### **AMENDMENTS TO THE DRAWINGS**

## REMARKS

FIG. 6.

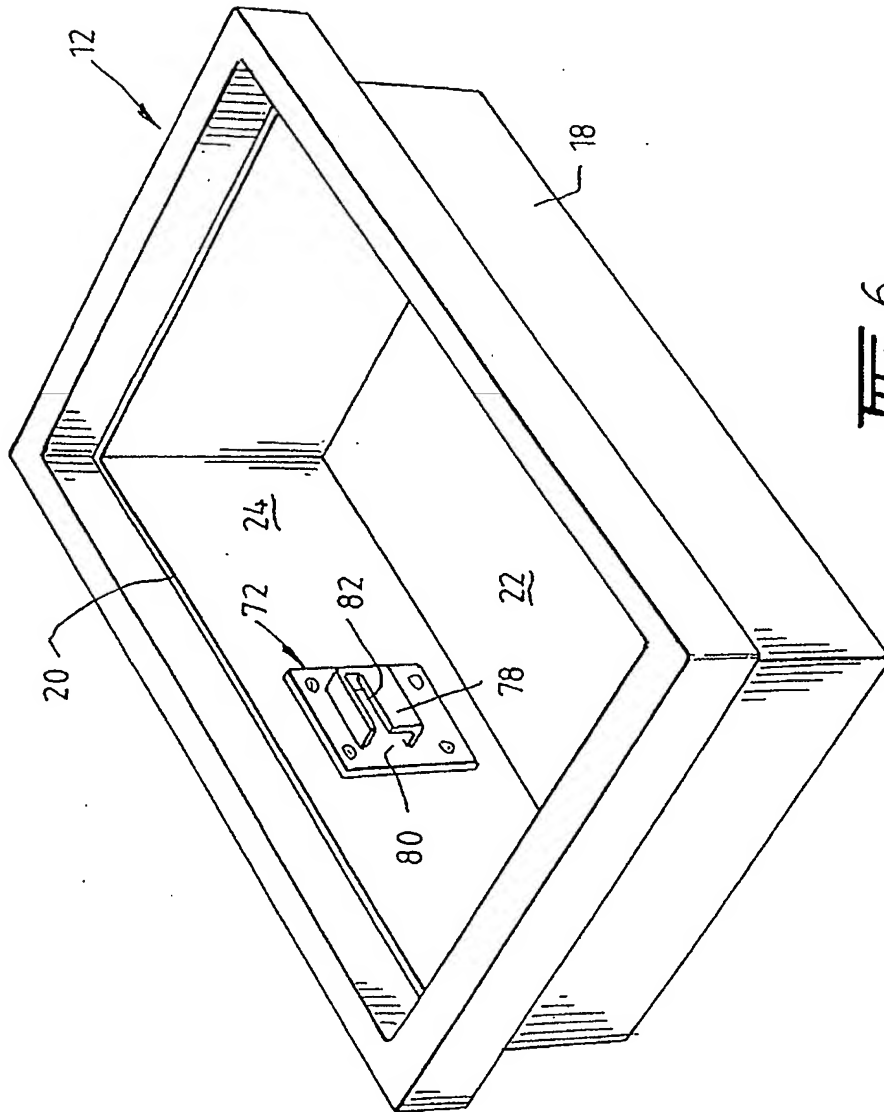
The attached sheet of drawings includes changes to Figure 7. This sheet, which includes Figures 6 and 7, replaces the original sheet including Figures 6 and 7. In Figure 7, previously omitted element identifier 79 has been added.

Element  
 Number  
 Added
